LAMBCON ASSOCIATES

ASSESSMENT OF POTENTIAL VISUAL IMPACTS ARISING FROM REZONING OF LAND OFF SEASPRAY STREET, NARRAWALLEE

PRELIMINARY REPORT

FIG. 5b ASSESSMENT OF CURRENT SUBDIVISION PLAN

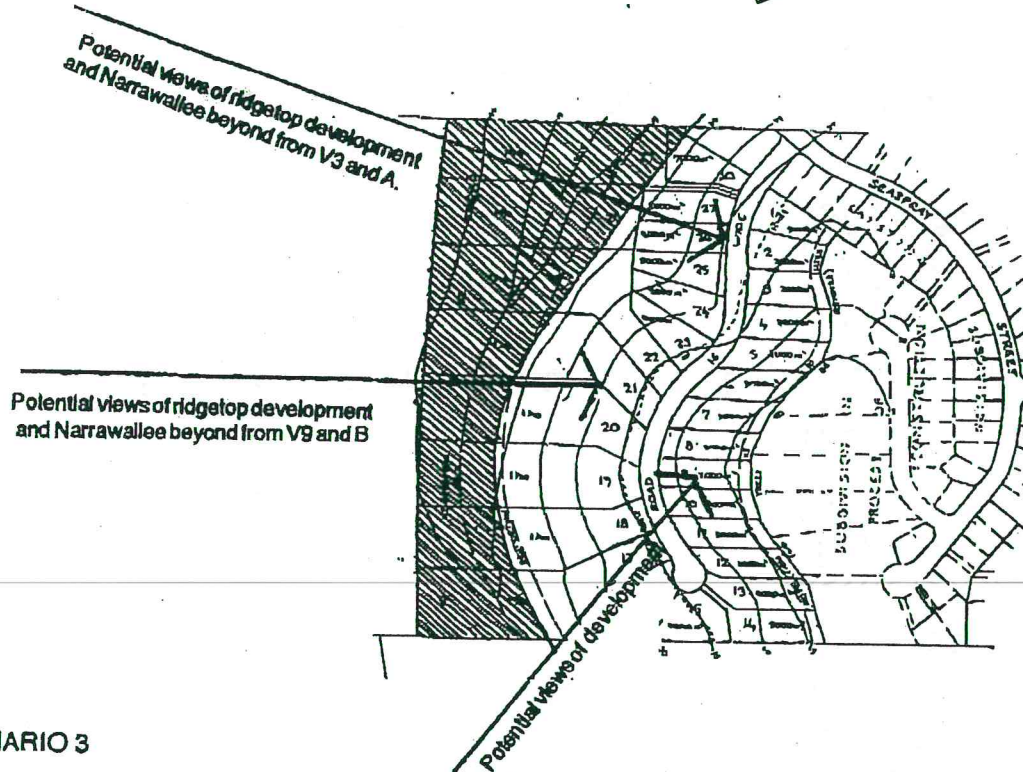
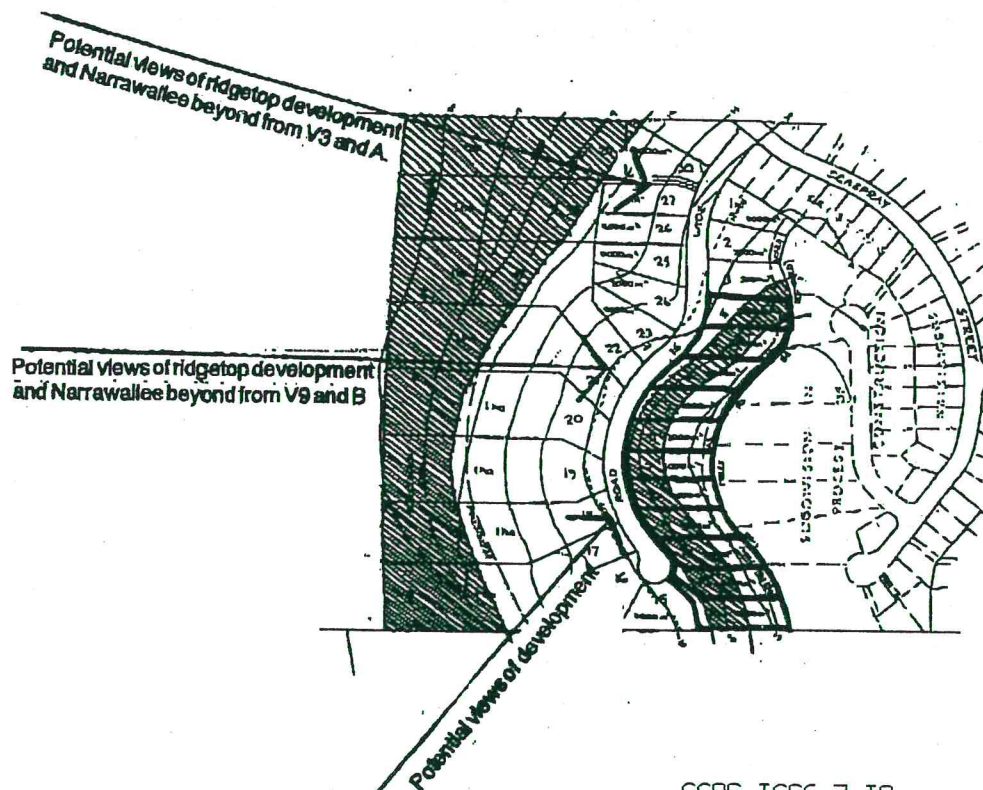
- We also examined the proposed subdivision plan for the land. We propose to supply detailed comments on this with our final draft of the report. Briefly however, we consider clearing of the north eastern corner of the site may be visible and buildings on the land could also be visible.

- Clearing up to the 42m contour could expose existing development in Narrawallee to view, as well as some buildings on the proposed subdivision.
- If clearing scenario 3 was literally applied to the land, there would be many lots in the eastern part of the site which would be unable to be built on, or others where considerably less than half of the lot would be useable.

- Setting the limit to clearing by reference to a contour, particularly on the eastern side of the site, would not be sufficiently sensitive to visual impacts and would need to be revised.

These diagrams point out potential conflicts between the two development scenarios proposed by New Lands Consulting and the current subdivision proposal.

□ Unusable sites; around 50% of the land not available for development

- A buffer should be provided on the southern side of the site.
- Alternative configurations and lot sizes will be suggested.
- Measures should be put in place to protect the visual integrity of the ridge vegetation and a wide down slope vegetated buffer provided, consistent with the visual sensitivity of the site.

FIG. 6 VISUAL QUALITY PRINCIPLES

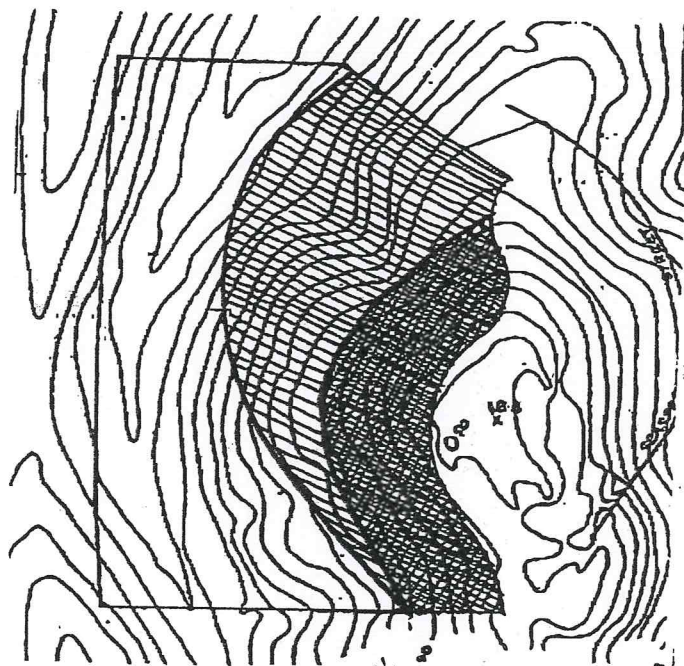
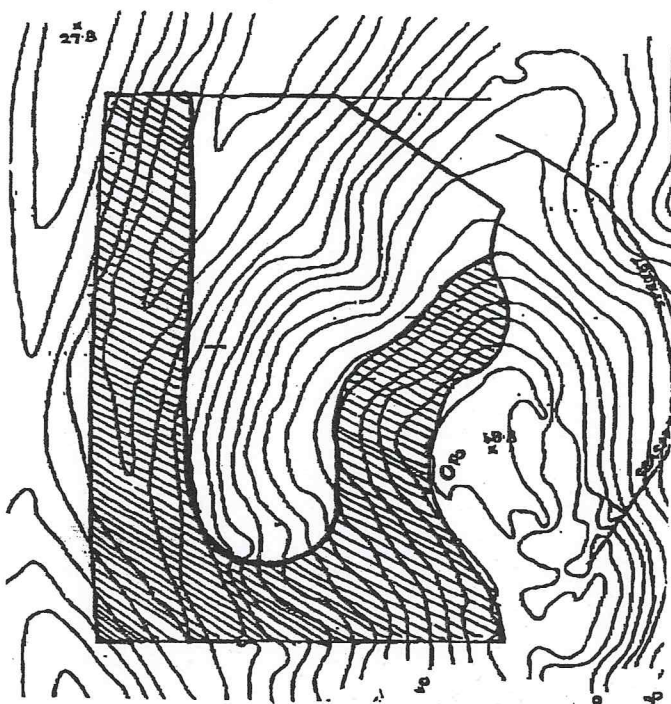
- We have drawn a plan of the site, which shows the visual constraints to clearing and general principles which should apply to development, which we identified using the sections and

direct observation. A draft indicating these principles of accompanies this brief report (Figure 6).

- We consider that any buffer zone which is retained with natural vegetation would have to be located so as to retain the vegetation of the entire visual horizon, which is in effect the ridge and upper slope of the site.
- The southern boundary should also have a buffer zone to prevent views in from location to the south west and from the cleared land immediately south of the site.
- The applicant suggested a buffer on the western boundary in one possible scenario and this may be sufficient to achieve this last effect.

Vegetation Buffer required of sufficient width to be sustainable
